# Disposition of Comments on ISO/IEC FCD 18023-1:200x

### Japan revised comments on FCD 18023-1 (SEDRIS Part 1)

2004-12-27, edited by Koreaki Fujimura

Figure 4.x — Link class notation

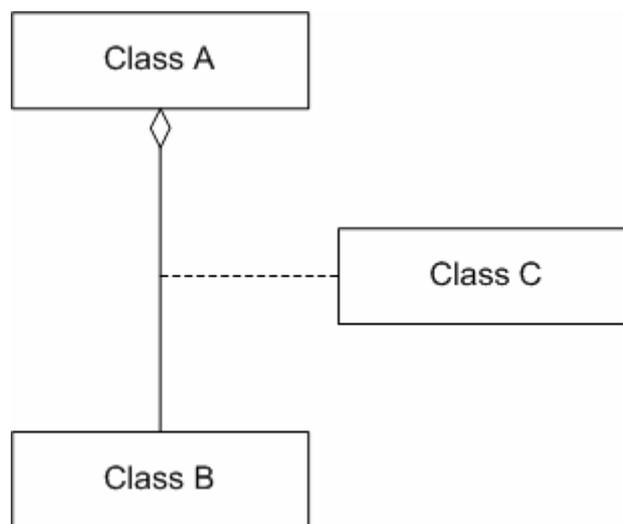
**RESPONSE:** Accept in principle. The following text replaces the last paragraph of 4.5.3:

“A link is a relationship between two class instances and must be unique between the class instances. Multiple links are allowed between two class instances provided they are differentiated through one of the optional UML mechanisms of role names, relationship names, or association classes. In this part of ISO/IEC 18023, no DRM class instance will have multiple links to another class instance without using an association class. An association class is a class that specifies the semantics of a relationship between classes. Such classes are termed *link classes*. Instances of link classes are termed *link objects*. Link objects specify information that applies to the specific relationship between the two class instances. In the DRM, some association and component relationships have a link class associated with the relationship. The notation for link class is shown in the Figure 4-x where the box containing “Class C” represents the link class:

Figure 4.X Precipitation rate

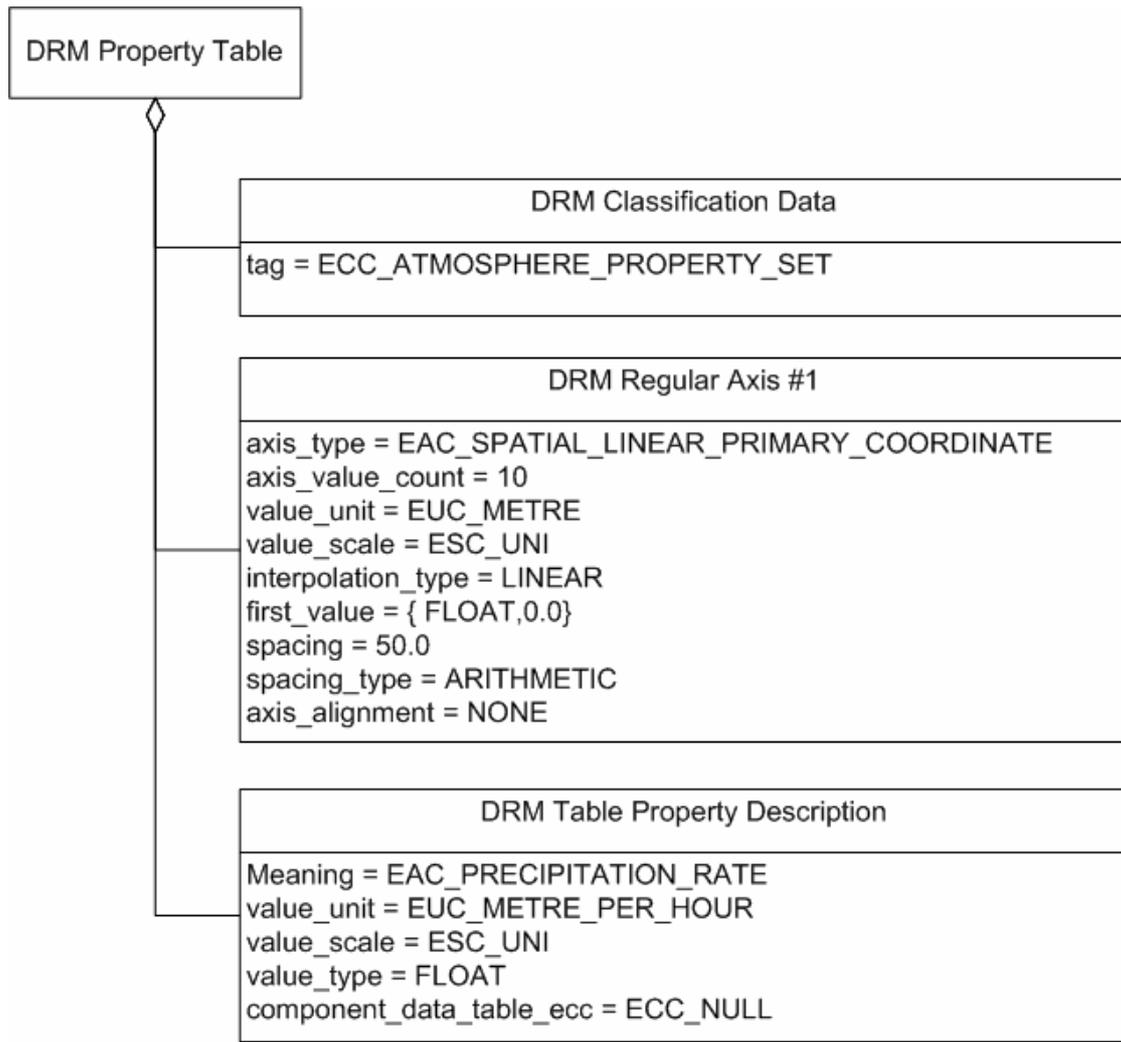
**RESPONSE:** This is actually about 4.9.1. The following text replaces the content of 4.9.1:

The number of dimensions of the cell data array is determined by the number of ordered [<DRM Axis>](#) instances aggregated by a given [<DRM Data Table>](#) instance. The `axis_value_count` field of each [<DRM Axis>](#) component specifies the number of cells in its corresponding dimension. The combination of the `axis_value_count` values defines the extents of a [<DRM Data Table>](#) instance. Subsections of a [<DRM Data Table>](#) instance’s cell data are termed *sub extents*. The order of the cell data is determined by the ordered [<DRM Axis>](#) components with the data corresponding to the final [<DRM Axis>](#) component varying the most.

EXAMPLE 1 A [<DRM Data Table>](#) subclass instance of [<DRM Property Grid>](#) with one [<DRM Axis>](#) subclass instance of [<Regular Axis>](#) as specified in Figure 4.X would have 10 cell values, sub extents from [0] to [9], and the data cell layout given in Figure 4.X +1.

**Figure 4.X+2**

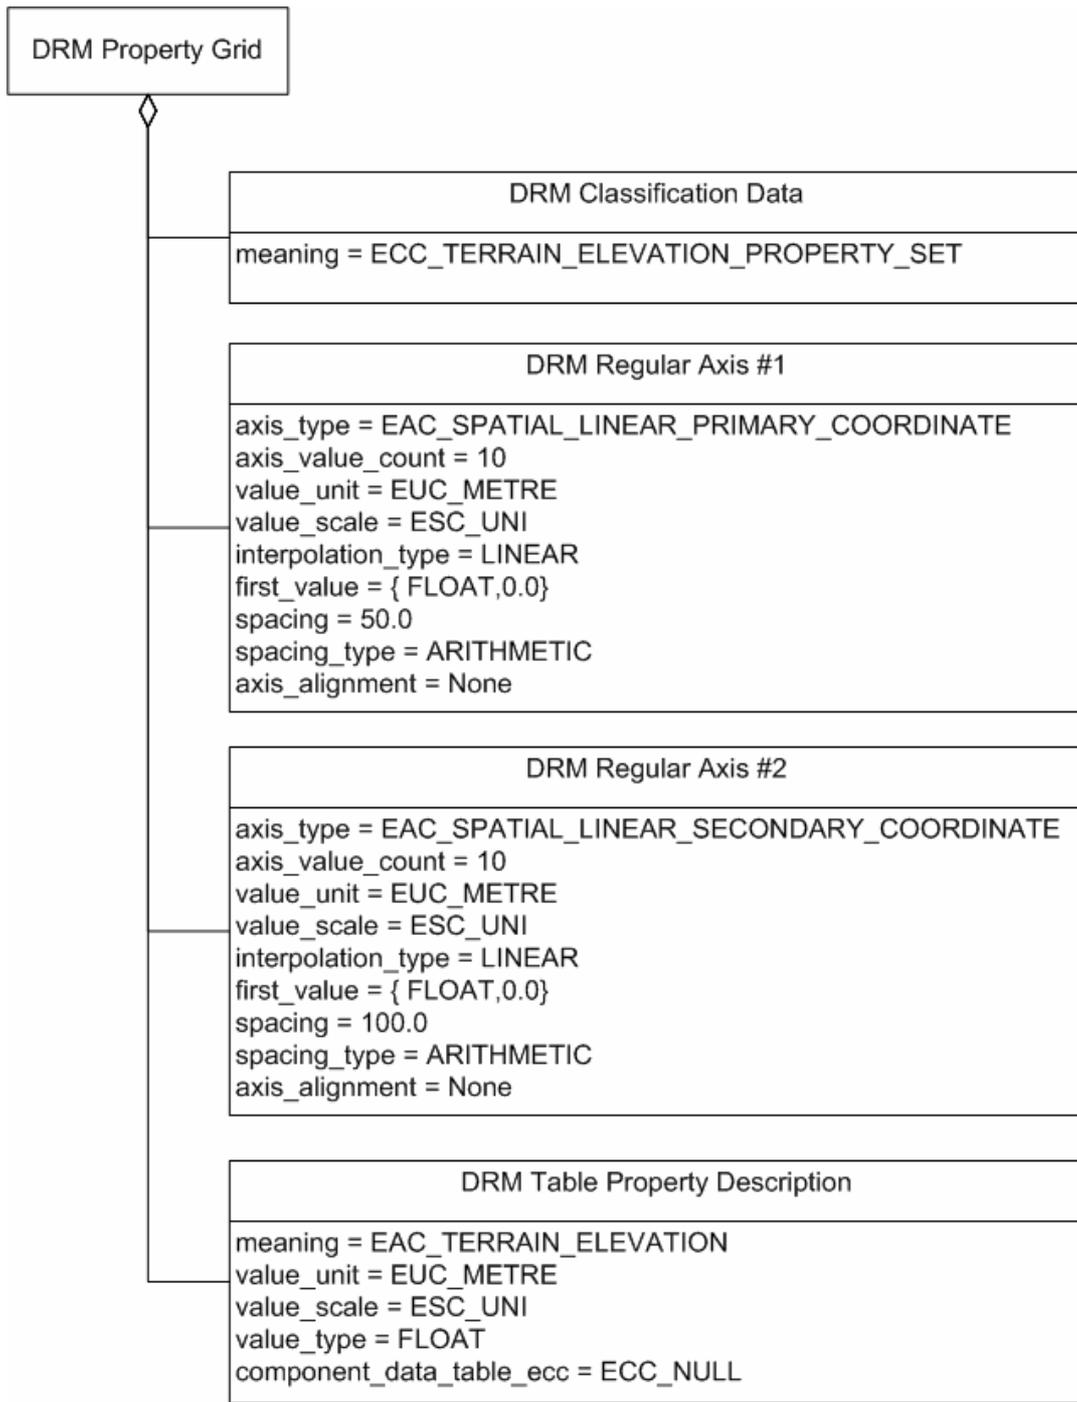
EXAMPLE 2 A <DRM Data Table> subclass instance of <DRM Property Grid> with two <DRM Axis> subclass instances of <Regular Axis> as specified in Figure 4.X would have 50 cell data values, sub extents from [0,0] to [9,4], and of the data cell ordering as shown in Figure 4.X+1.

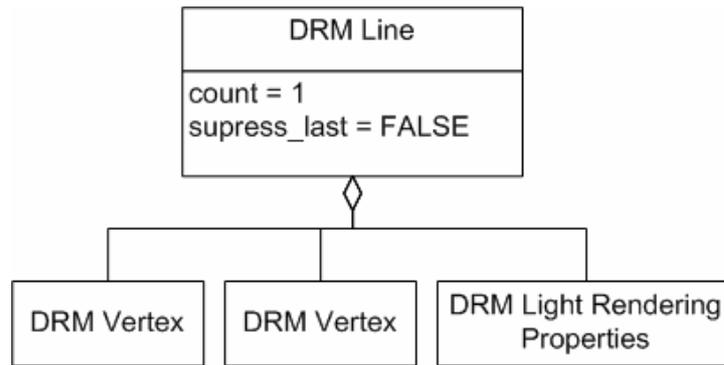
**Final look of paragraph (existing text with changes made and including example figures):**

The count field of a [<DRM Linear Geometry>](#) instance indicates how the [<DRM Linear Geometry>](#) instance is to be rendered. A count field value of zero for a given [<DRM Linear Geometry>](#) instance L indicates that L is to be rendered as one solid line segment, and the suppress\_last field does not apply. If count is greater than zero and L has a [<DRM Light Rendering Properties>](#) component the following applies:

- a. count is the number of evenly spaced light points to be rendered along L.
- b. The distance between light points is calculated by dividing the total length of L by count .
- c. If count is 1, a single light point is placed at the halfway point of L and suppress\_last field does not apply.
- d. If a [<DRM Light Rendering Properties>](#) component is present, then the fields of the [<DRM Light Rendering Properties>](#) are applicable to each light point, refer to 4.15.3.5.
- e. If a [<DRM Rendering Properties>](#) component is present it is applicable to each light point, refer to 4.15.3.4.
- f. No additional constraints are in effect.

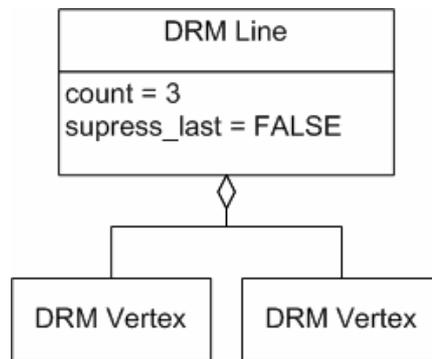
EXAMPLE 1 [<DRM Linear Geometry>](#) subclass [<DRM Line>](#) instance rendered as a single light point

Figure 4.W <DRM Variable> usage

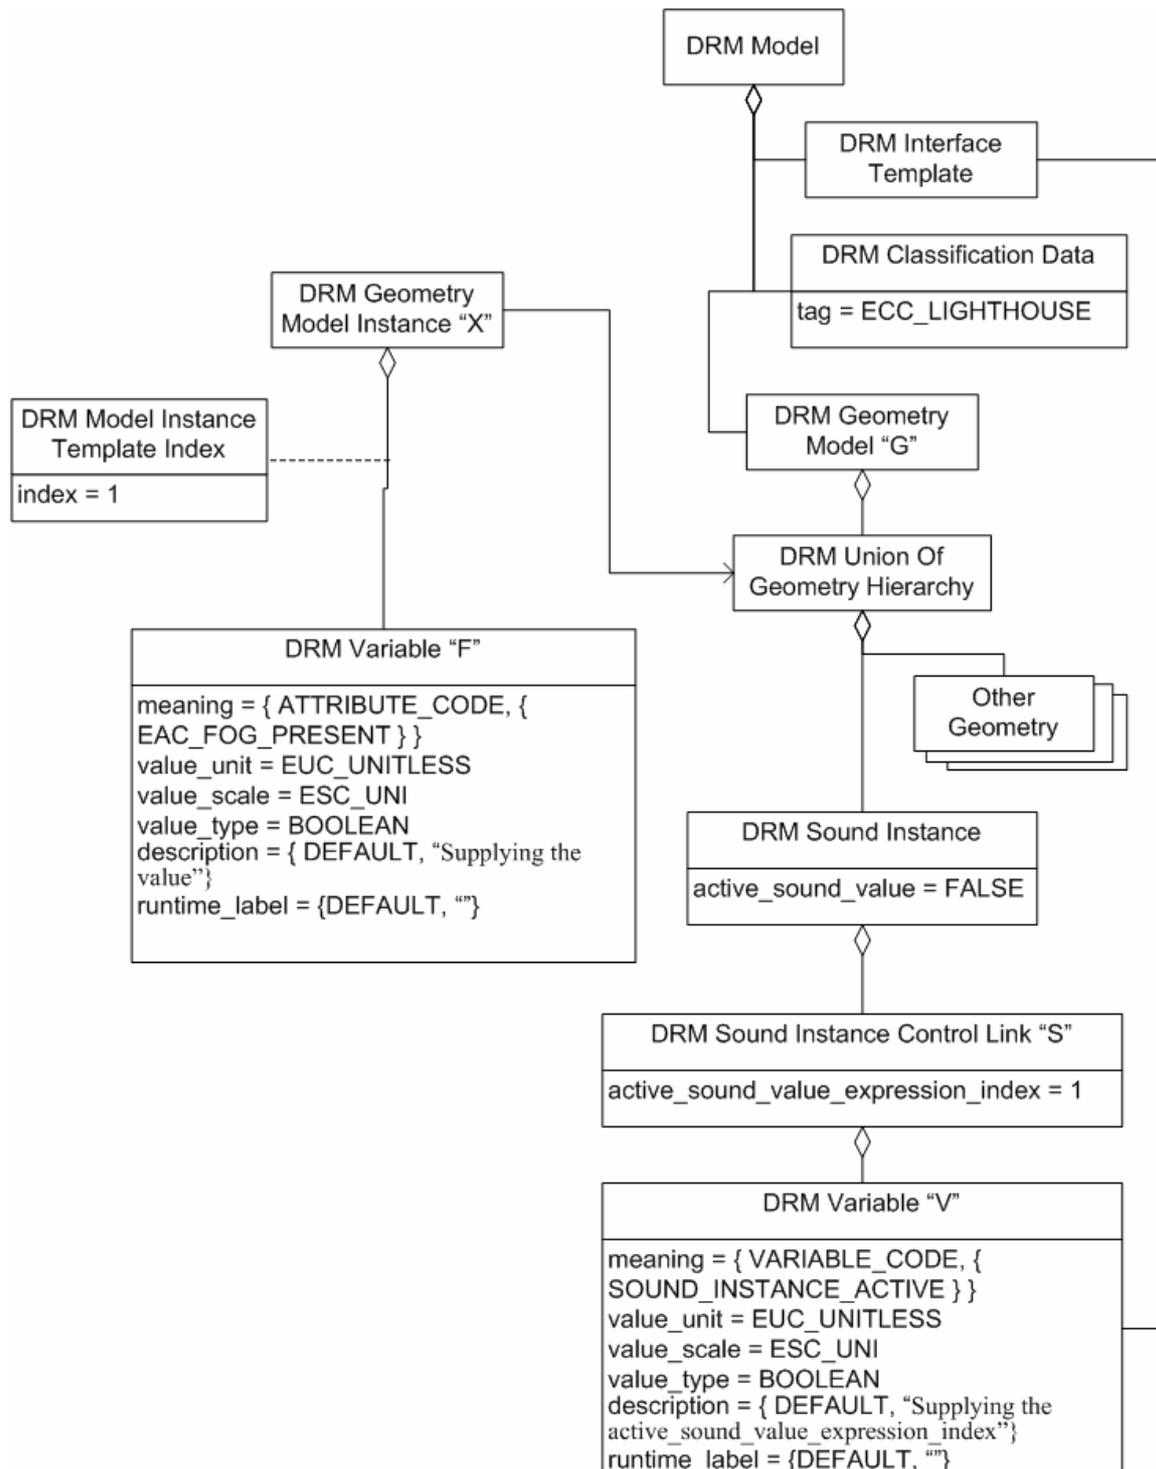
X supplies a <DRM Variable> instance F representing the existence of fog to be evaluated when L is instanced. Whether or not the foghorn sound is active depends on the environment variable F that indicates whether fog is present.

X specifies that F is to be substituted for L's <DRM Variable> instance V by means of the <DRM Model Instance Template Index> link object on the relationship between X and F. The index value of 1 specifies that F is to be substituted for the first <DRM Variable> instance associated with L's <DRM Interface Template> component.
